RE: Roberts' Improvements to Nenana Ave.

Re: Roberts Property – Nenana Avenue Sight Distance Analysis – Cannon Beach, Oregon
Technical Letter #1 – Supplemental Sight Distance Analysis

This transportation analysis supplements the September 12, 2020 Roberts Property – Nenana Avenue Sight Distance Analysis (Sight Distance Analysis) prepared by Clemow & Associates and addresses the September 22, 2020 City of Cannon Beach Nenana Avenue Plan Review #3 Memorandum prepared by Windsor Engineers.

2
12 **BARRIER CONNECTIONS**
SCALE: 1"=2'

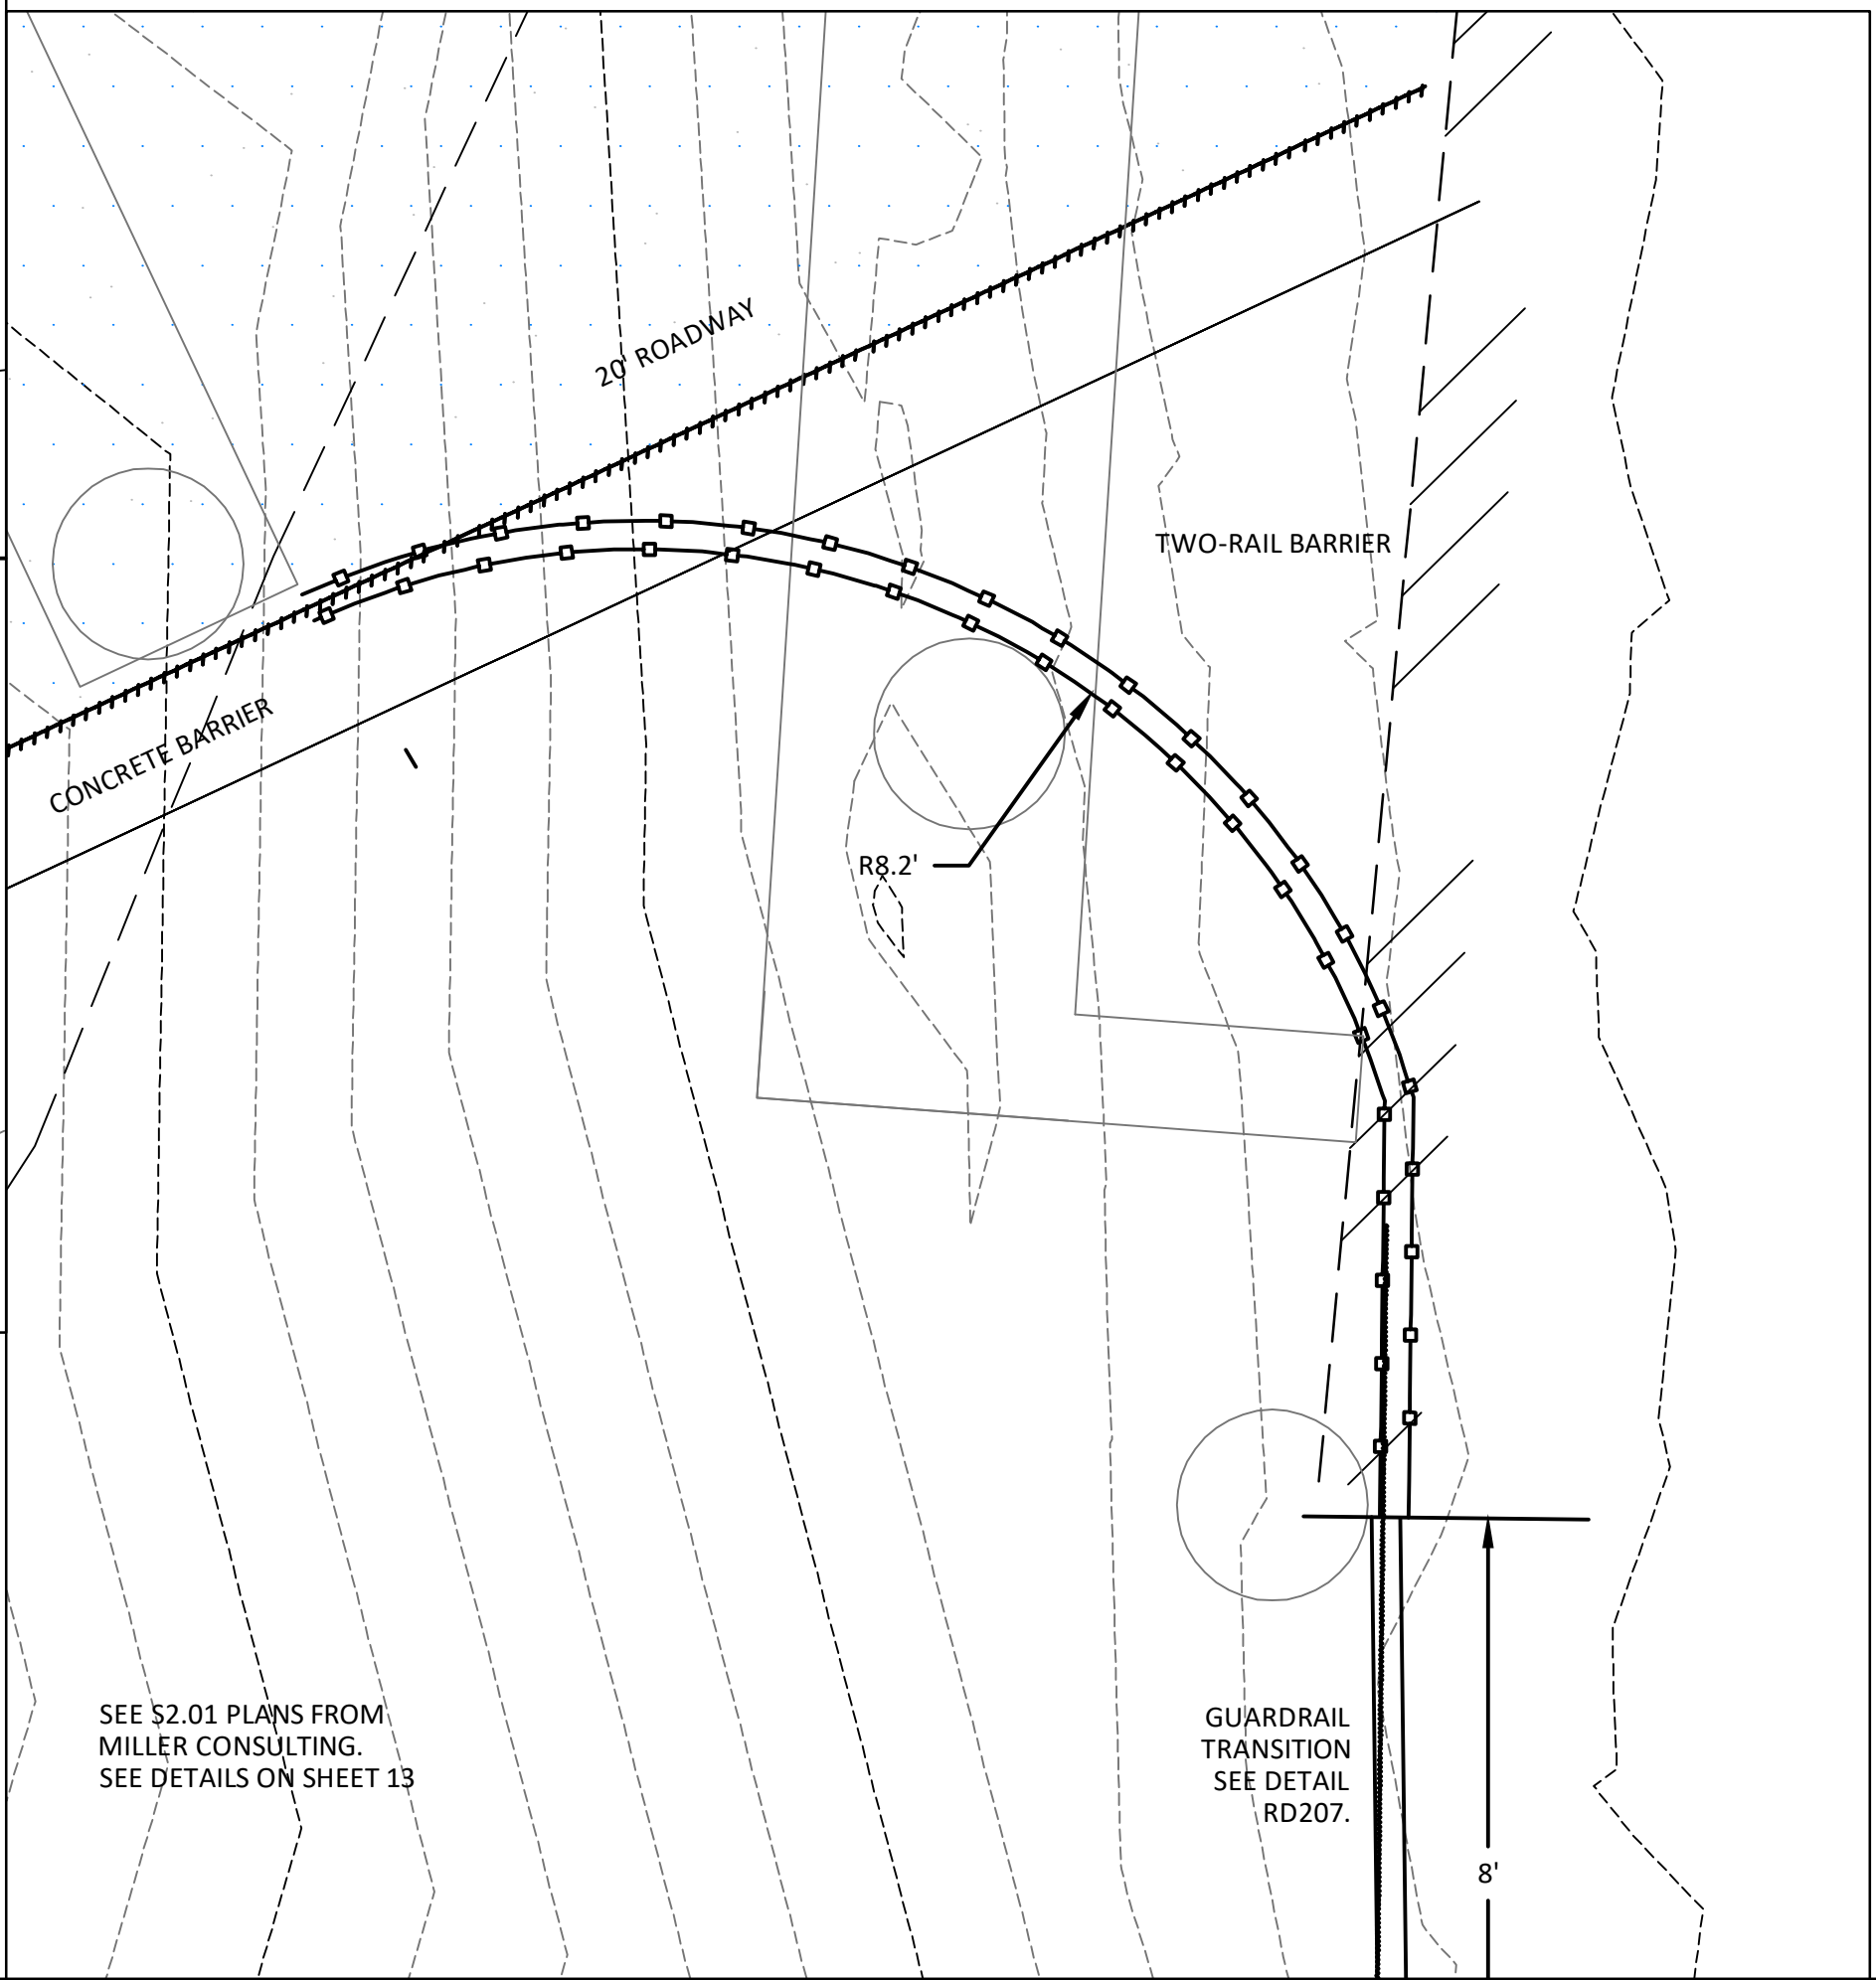
Windsor requested additional plan detail for the end of the bridge and guardrails. Eric Watson has previously provided those to the city via a sharefile because of their large size. They can also be accessed through this link: <https://miller-se.sharefile.com/d-s731e6cebb264b49a>

On the south side of Nenana adjacent to Hemlock, a new bridge rail will be installed to replace the existing W-beam guardrail. The proposed design allows a driver to ‘see through’ the bridge rail and will not obstruct intersection sight distance.

Attached is a drawing showing the revised transition from bridge to guardrail.
